Date: May 7, 2026
To: All Prospective Bidders
From: Candida Poinsette
Assoc. Director of Procurement Services
Re: Addendum Number 2
IFB # C1747 – Façade Repairs – Kaufman Hall

Re: Façade Repairs
Kaufman Hall
Fashion Institute of Technology
406 West 31st Street
New York NY 10001

Questions IFB # C1747 – Kaufman Façade Repairs

1 SITE PLAN & PROTECTION PLAN
 A-100 SCALE: 3/32" = 1'-0"

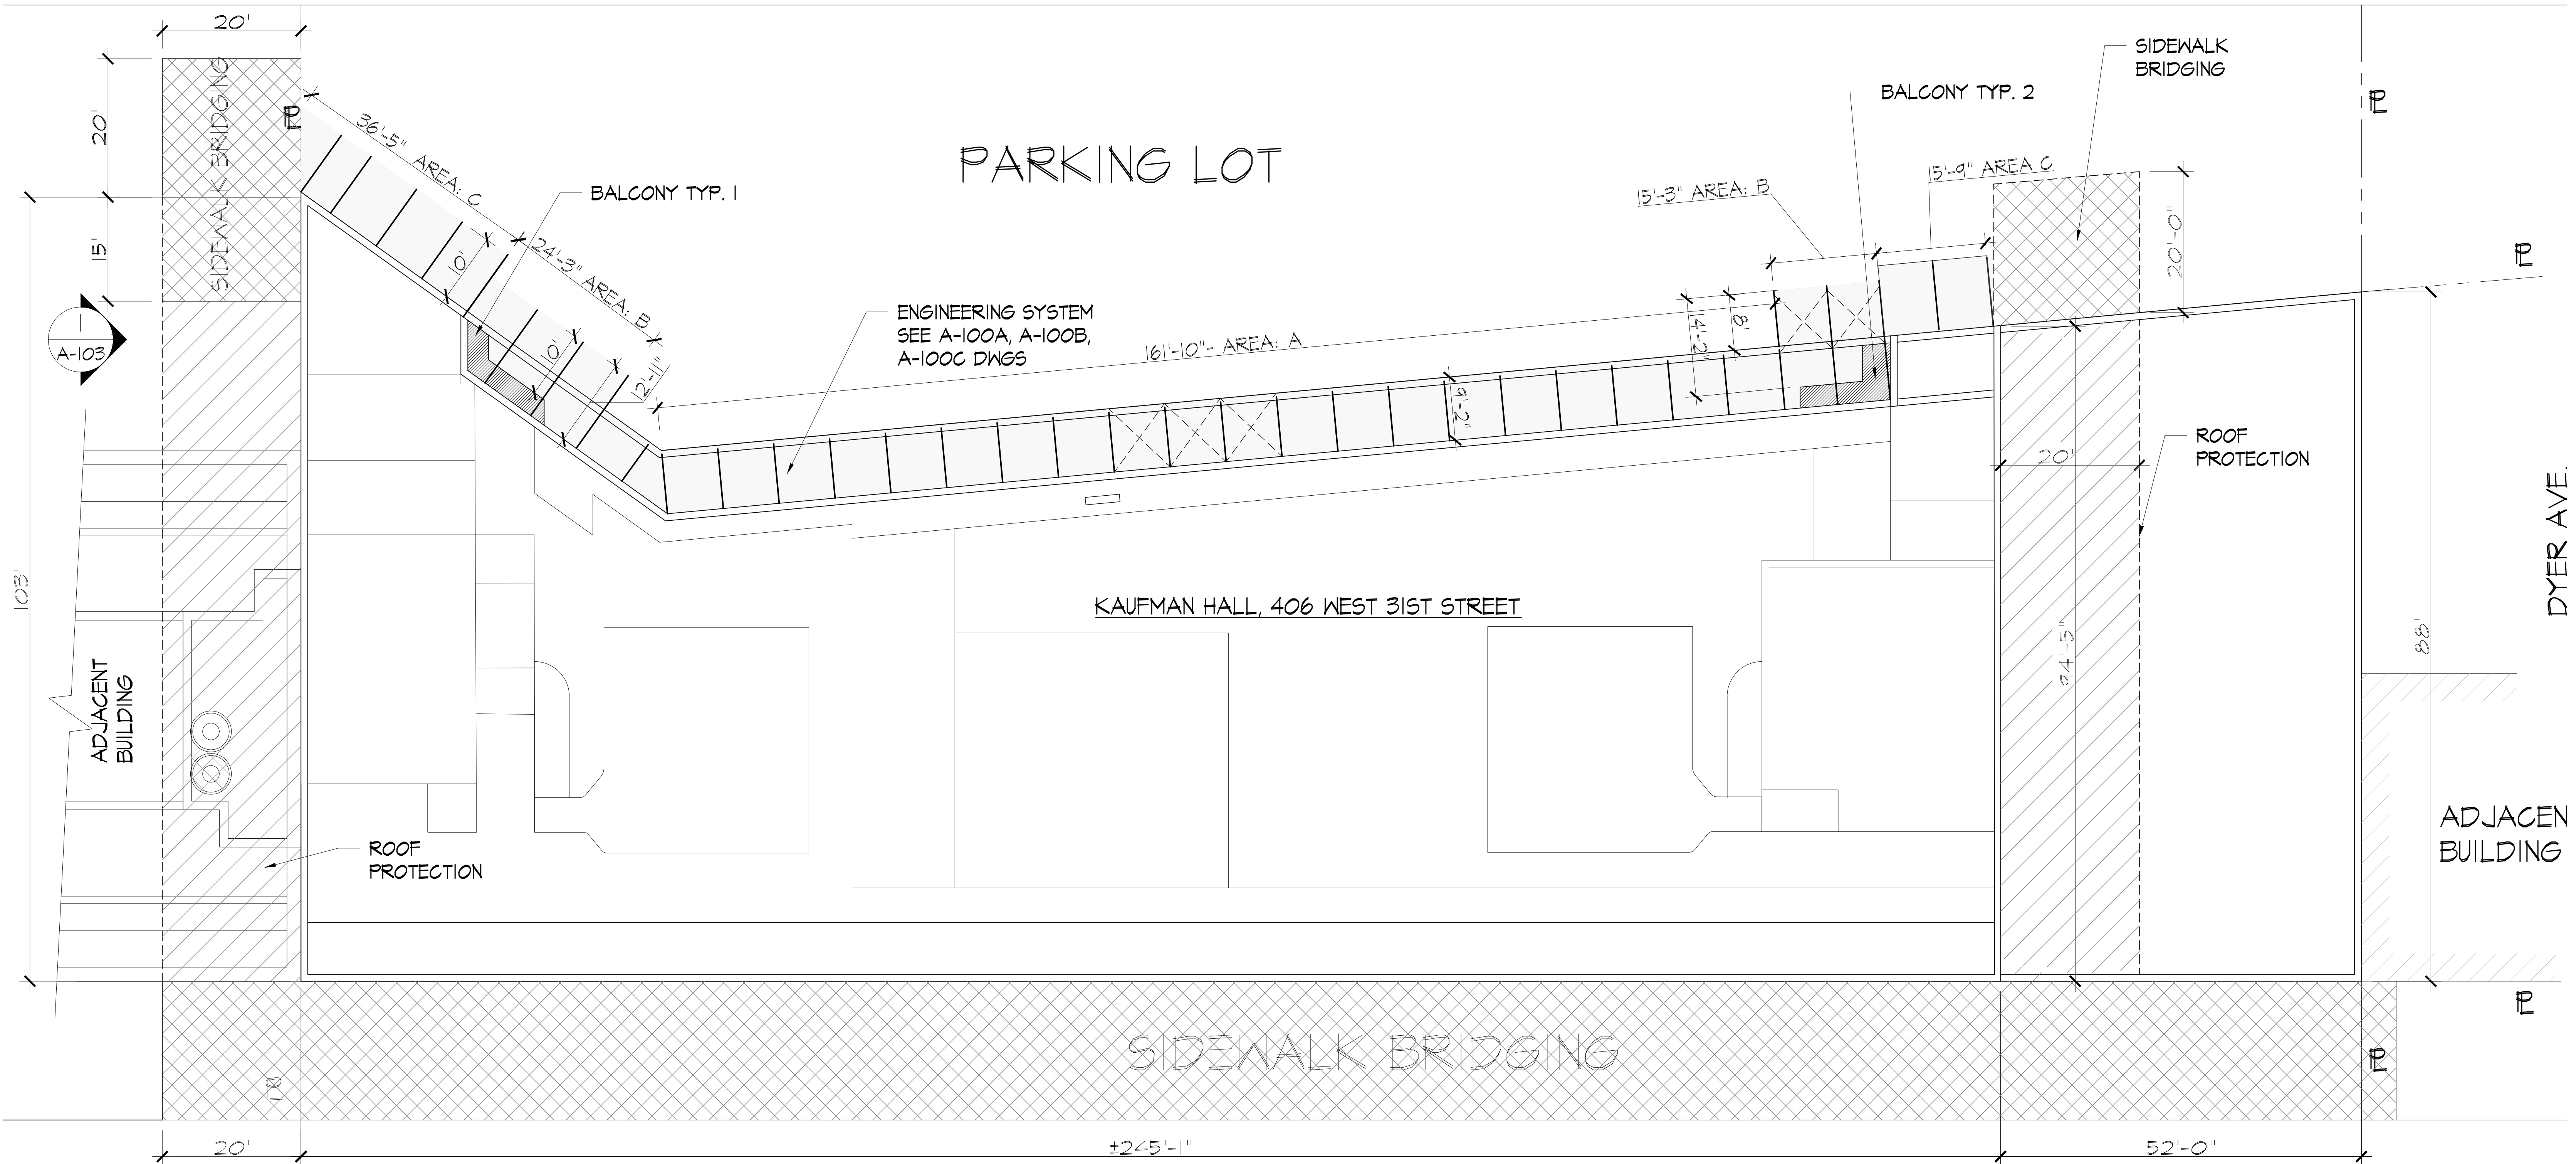
RFI #3 Please advise whether the sidewalk shed at the south elevation is required to cover the full width of the bus area, or if it should be constructed in accordance with the width indicated on Drawing A100.00.

RFI #7. For the Southwest corner, DWG A100.00 shows Sidewalk Shed protection 5ft beyond the extents of the west wall of the adjacent Garage Building, is this still needed in the Option 2 scenario where there is a 30ft closed off construction zone? If we utilize the proposed Construction Fence with Closed Access, the fence line will enter this region and cross the existing neighboring fence, how would we go about handling accessing this region and are we able to make this a controlled access zone?

RFI #9. For the West Side Parapet Repairs, is overhead protection not needed along the west side wall where there is no attached building (*see DWG100.00*) because it is already a Closed Off Construction Zone without public access? Is this property part of FIT's property or an adjacent neighbor? Is there an Access agreement and can we consider this a Closed Access Zone (Are we responsible for Closing Off this Area?)

RFI #3 Response. Please see RFI #2 response. Sidewalk bridging at the south façade will now be limited to the bridging to be installed at the public sidewalk and yard of the east neighbor building.

RFI #7 Response. Please refer to responses to RFI #2 above, revised bid form and revised drawings. Sidewalk shed will not extend 5' beyond west wall.

RFI #9 Response. No overhead protection is required. There is no access to the adjacent property. The property is not owned by FIT.

1 PLAN VIEW OF PLATFORM @ AREA C
A-100A SCALE: 3/8" = 1'-0"

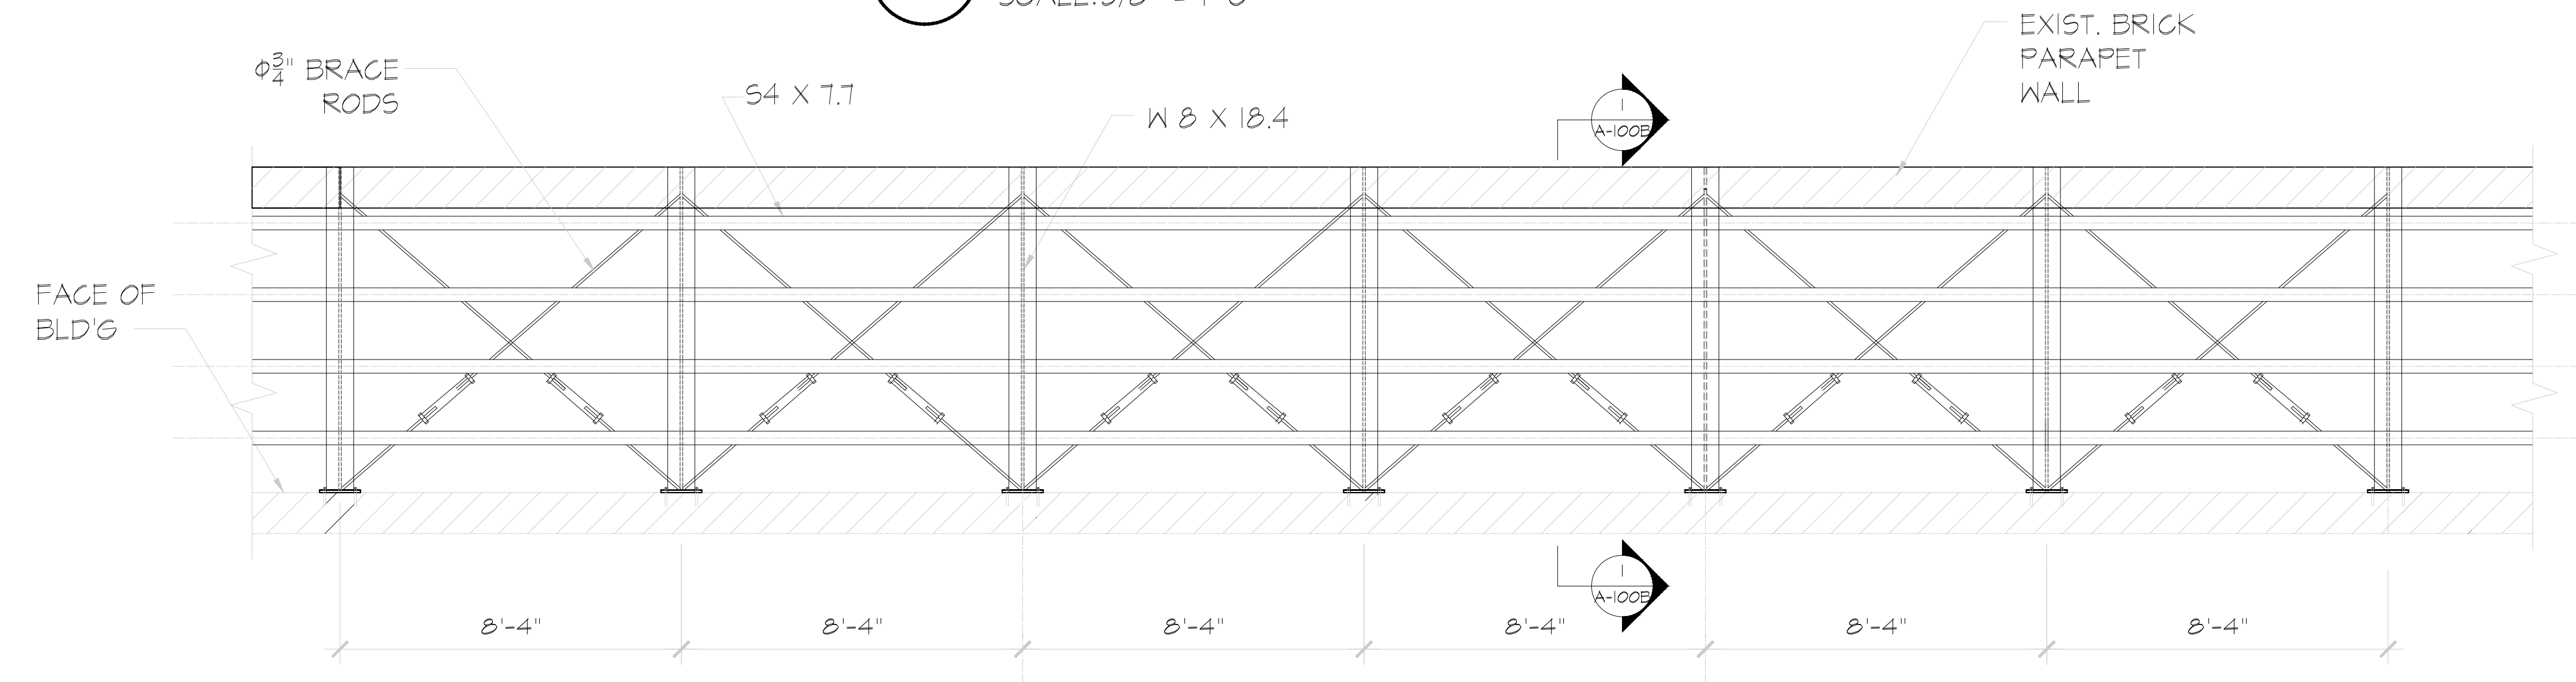
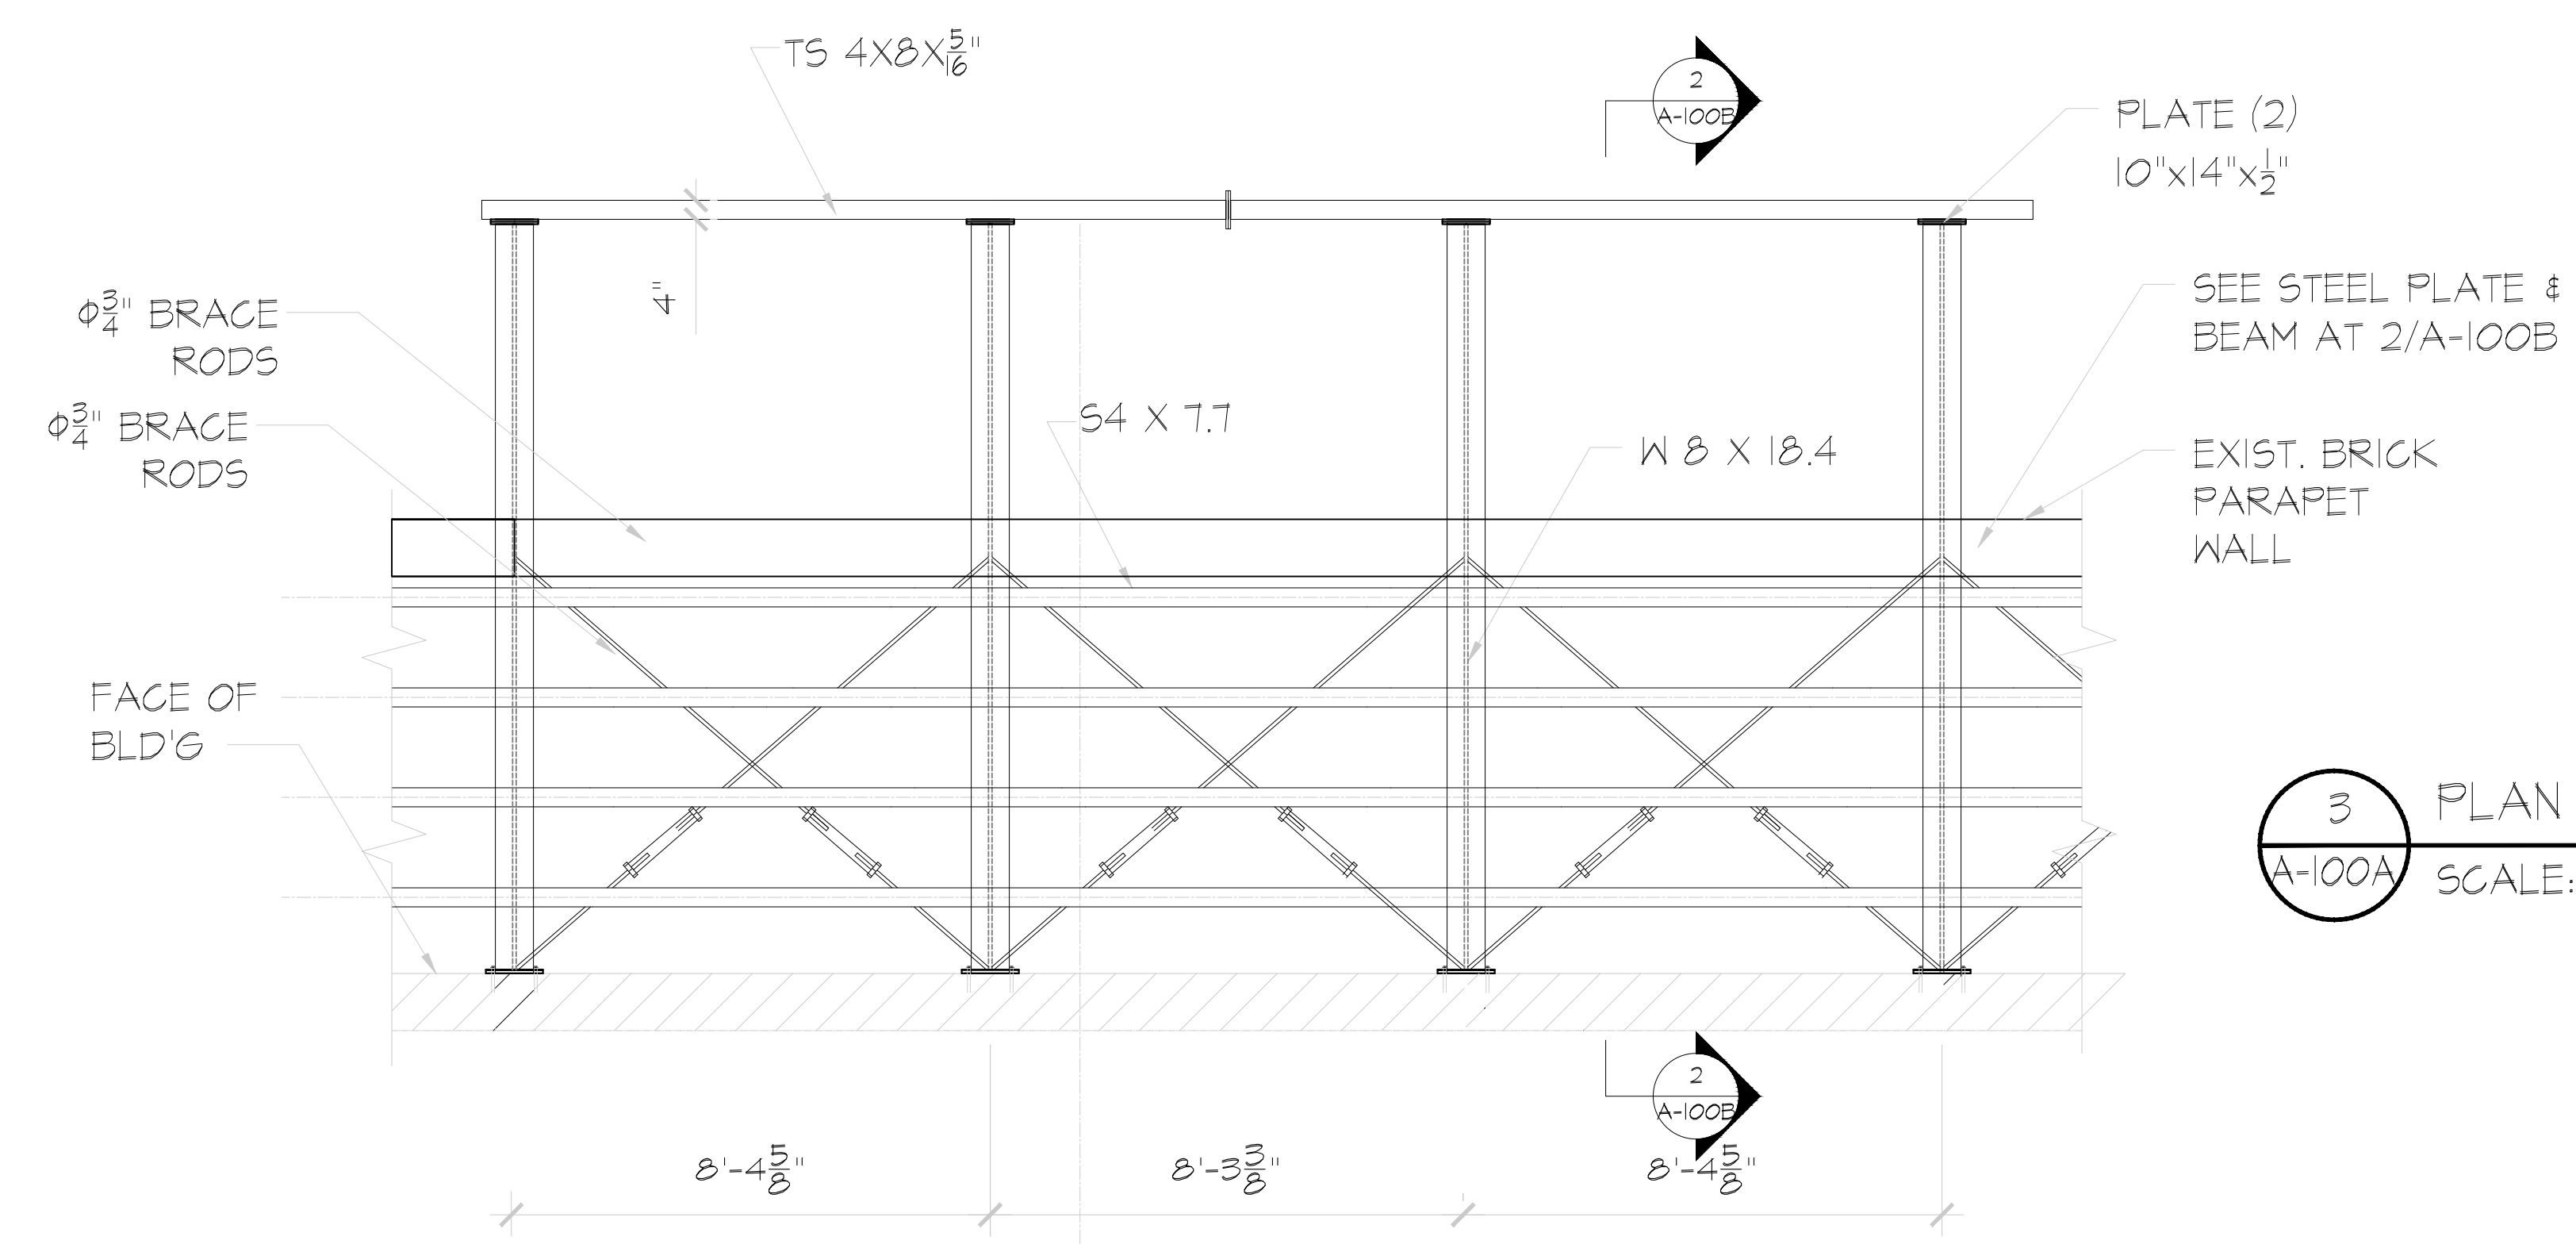
RFI #2. Please clarify the scope of work referenced in the bid form under Phase 1 – Section II, Part 1a and 2a, pertaining to the “Alternate – Engineered Enclosure System” at the balconies and full south façade. Specifically, we request confirmation on whether this system is intended to be a standard pipe scaffold with netting, or if a different type of engineered enclosure system is required. Additional details regarding the system specifications, performance requirements, and any design criteria would be appreciated to ensure accurate understanding and pricing.

RFI #2 Response. Please see revised Contractor’s Proposal Bid Form and revised Dwg. A-100 and new Dwgs. A-100A and A-100B.

In order to avoid installation of overhead sidewalk bridging over the bus parking area, protection at the south façade will consist of a cantilevered platform supported above the 1st Floor setback roof with an Engineered Enclosure System erected on top of the platform. This includes the windowless walls at the east and west ends of the south façade as well as the entire middle section above the building’s 1st Floor setback roof.

Refer to the drawings for details of the platform installation. In summary, outrigger beams are to be installed, attached to the building’s exterior wall at one end and bearing on the setback

roof's parapet wall at the other. The outrigger beams will support the equivalent of a sidewalk bridge deck, including q-deck, planking and parapets.

On top of this deck pipe scaffolding is to be installed. For the purposes of this pricing exercise and to meet the minimum requirements of an Engineered Enclosure System as defined in BC 3309.17, the Engineered Enclosure System will consist of standard pipe scaffolding, black mesh netting and an additional layer of 16-gauge wire netting outside the black mesh.

Note that the design of the access staging and platform provided on the attached drawings is for pricing/scoping only. Final engineering and permit filing to be by the Contractor's team and made in full accordance with the approved Site Safety plans. Contractor to submit engineered drawings for review by DTA.
